FAX COVERSHEET

FOLLOWING PAGE IS MY VERSION
OF O/P STAGE, I CHANGED IT A LITTLE TO
REDUCE QUIETCENT CONSUMPTION, THIS WILL BECOME
IMPORTANT WHEN WE ADD ALL THE CURRENTS UP
I SUSPECT!! THANK YOU FOR P.O.R. ETC.

DEC 95 I output III

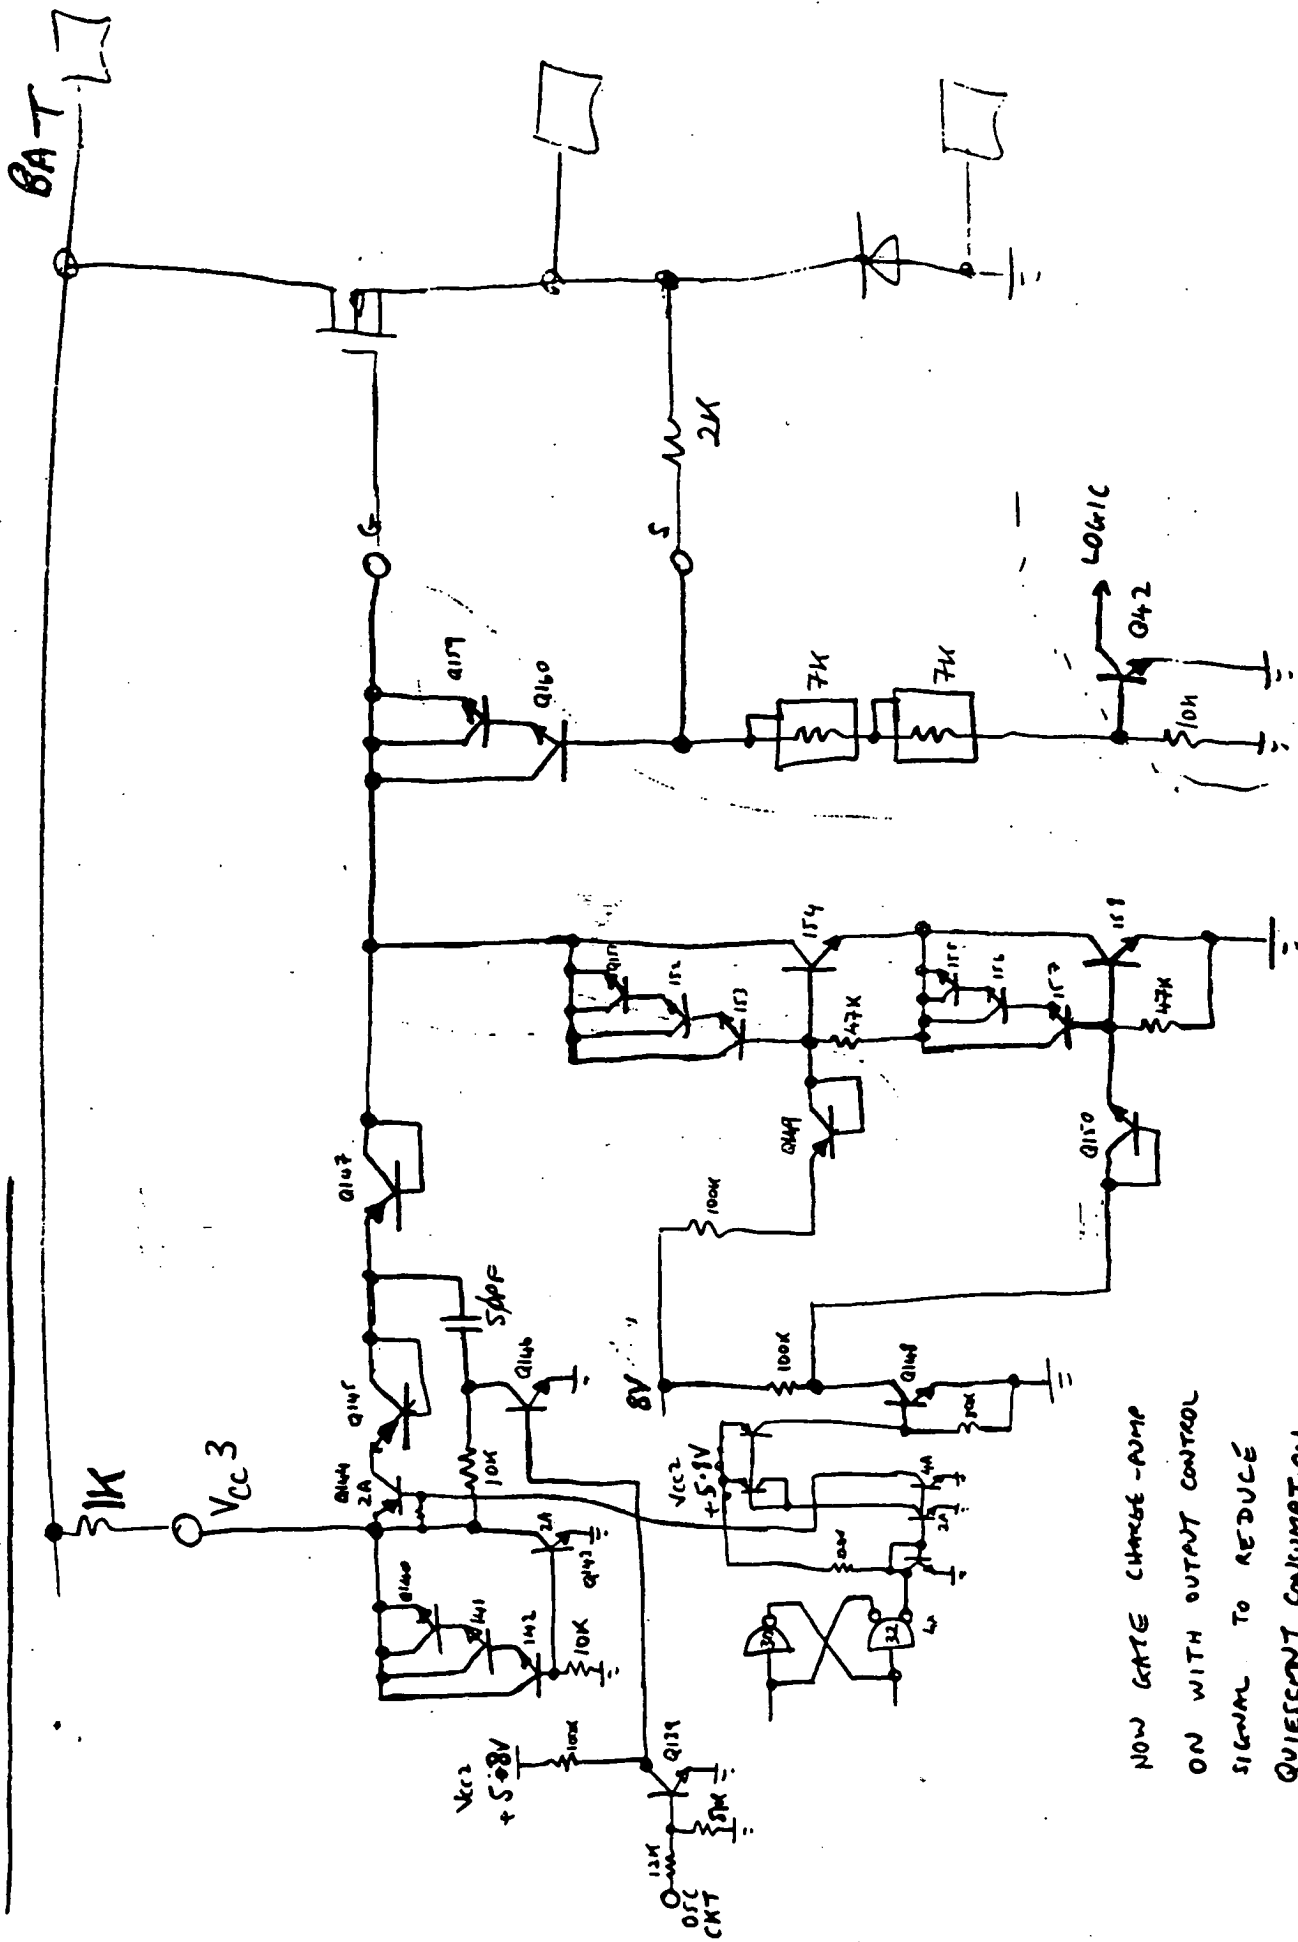
NOW GATE CHARGE-PUMP
 ON WITH OUTPUT CONTROL
 SIGNAL TO REDUCE
 QUIESCENT CONSUMPTION
 AND ELIMINATE SERIES RESISTOR

DELCO 95I/55I CHARGE PUMP ETC - II

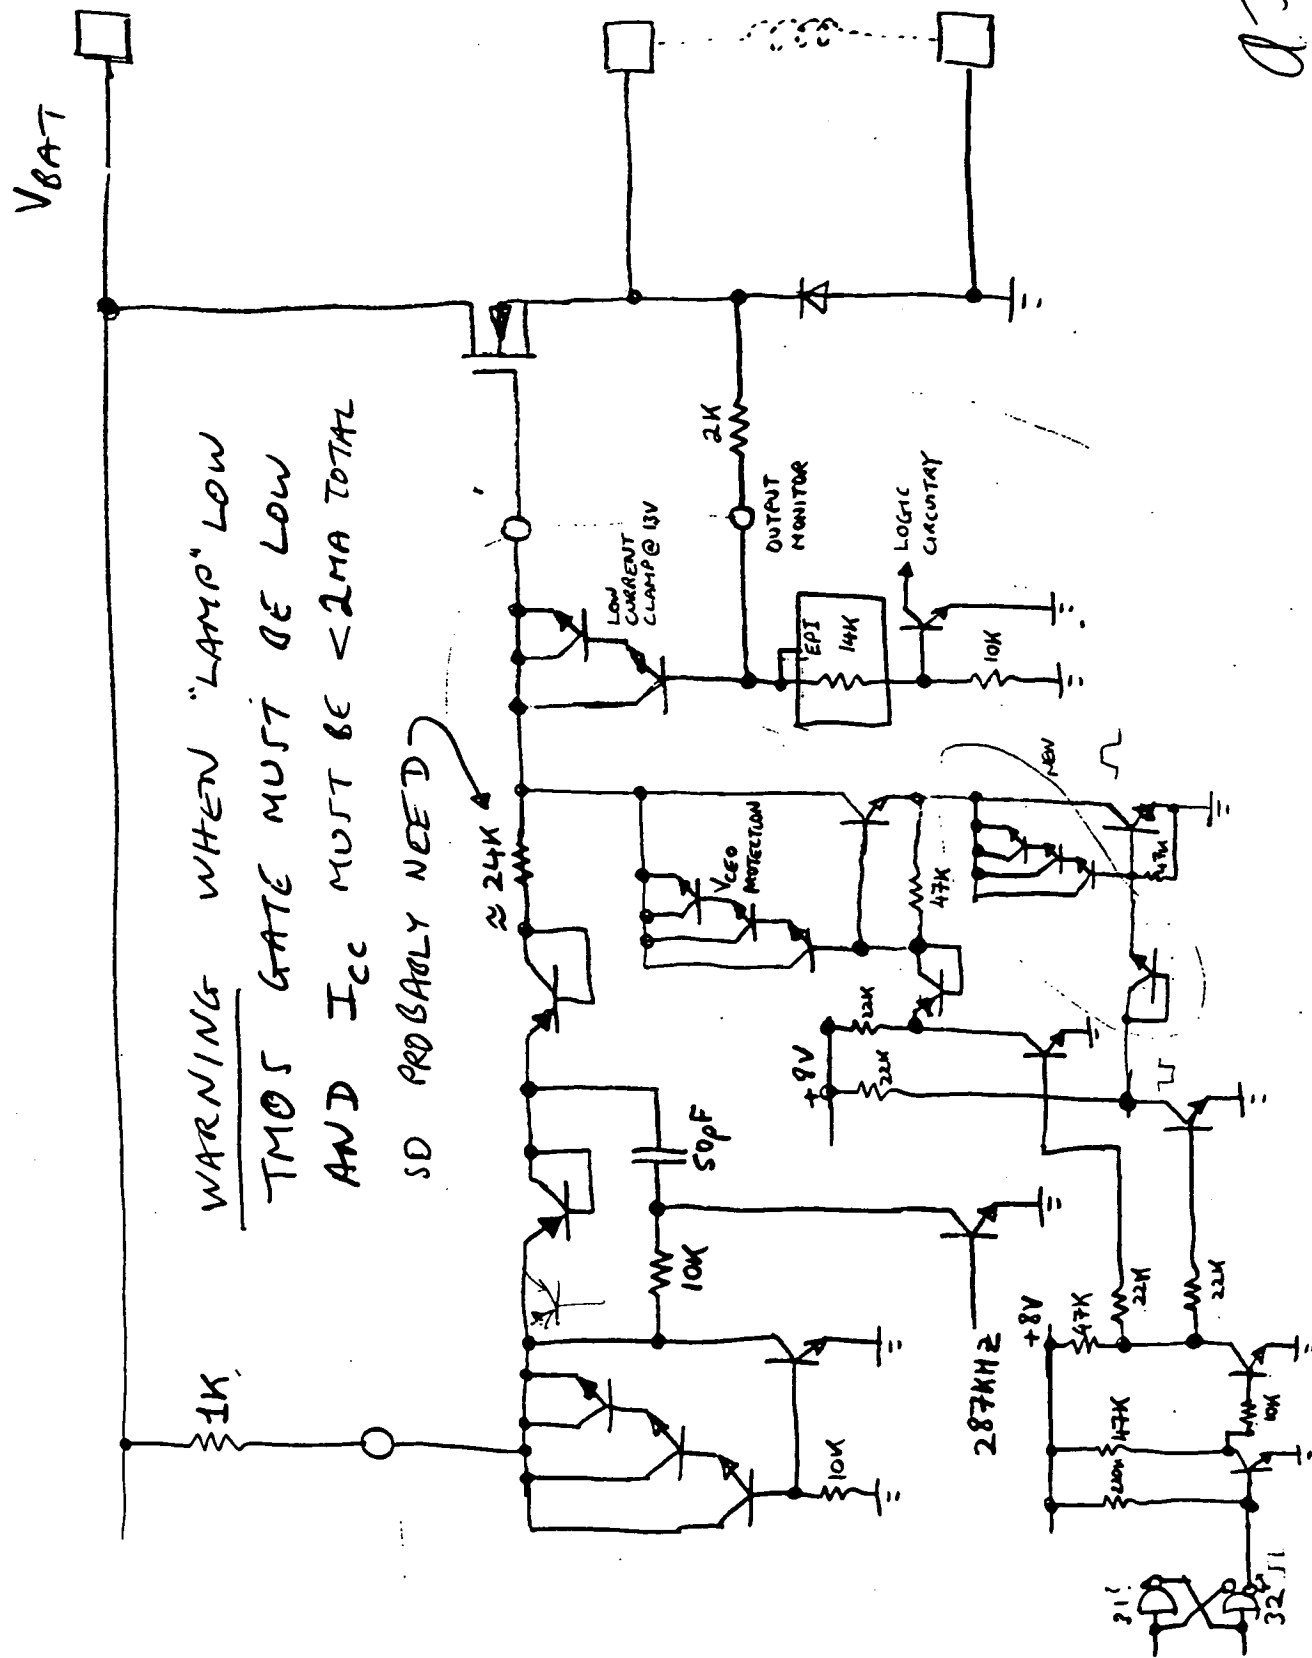
DELCO O/P STAGE II ... ADDED

SECOND 20V CLAMP
